SPECIAL COUNCIL MEETING MINUTES

JULY 26, 27 AND 28, 2011

2. REZONING: 105-167 West 2nd Avenue

Figure 1: Maximum Building Heights

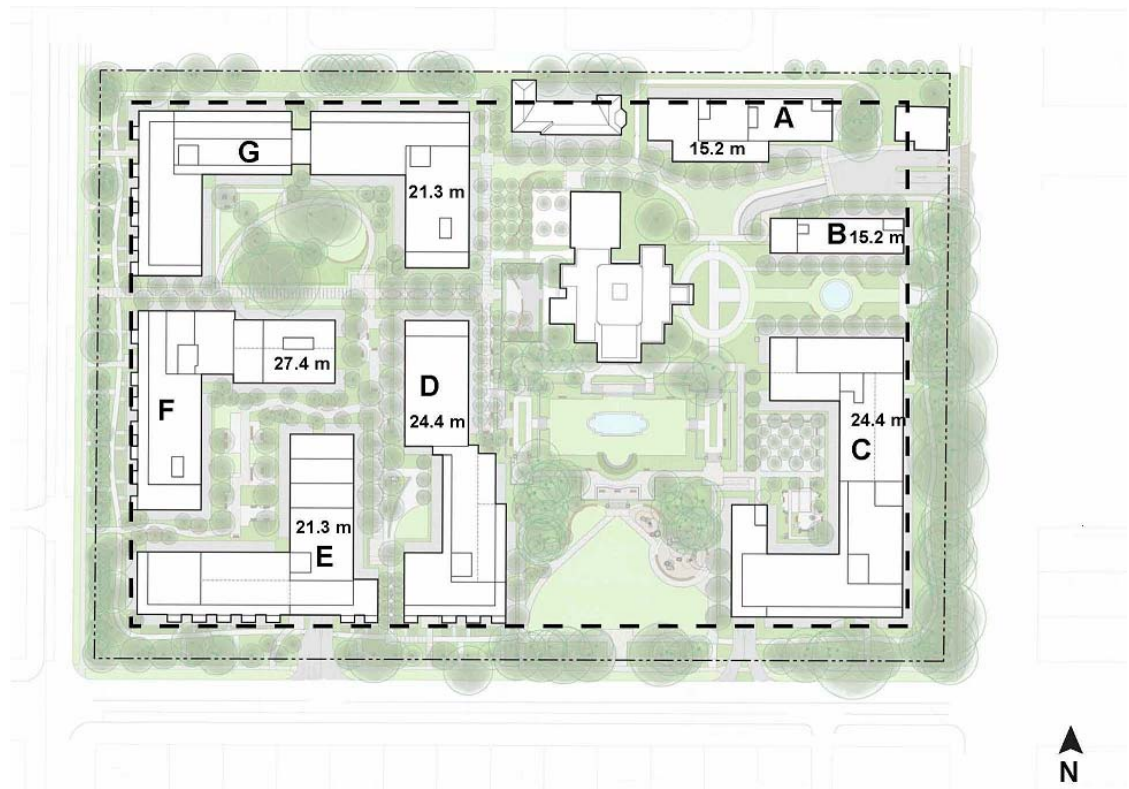
- E. THAT the Director of Legal Services be instructed to bring forward a by-law pursuant to Section 565.2 of the *Vancouver Charter* authorizing the City to enter into a Housing Agreement with the owner of the site to secure 202 dwelling units as rental on such terms and conditions as are described in Appendix B of the Policy Report dated June 24, 2011, entitled "CD-1 Rezoning and Heritage Revitalization Agreement at 7101-7201 Granville Street (Shannon Mews)", and as are satisfactory to the Director of Legal Services and to the Managing Director of Social Development.
- F. THAT Appendix A of the Policy Report dated June 24, 2011 entitled "CD-1 Rezoning - 7101-7201 Granville Street (Shannon Mews)" be amended as follows:
- a) Appendix A, Draft CD-1 By-law Provisions, Section 6. Height, be amended to insert Figure 1: Maximum Building Heights:
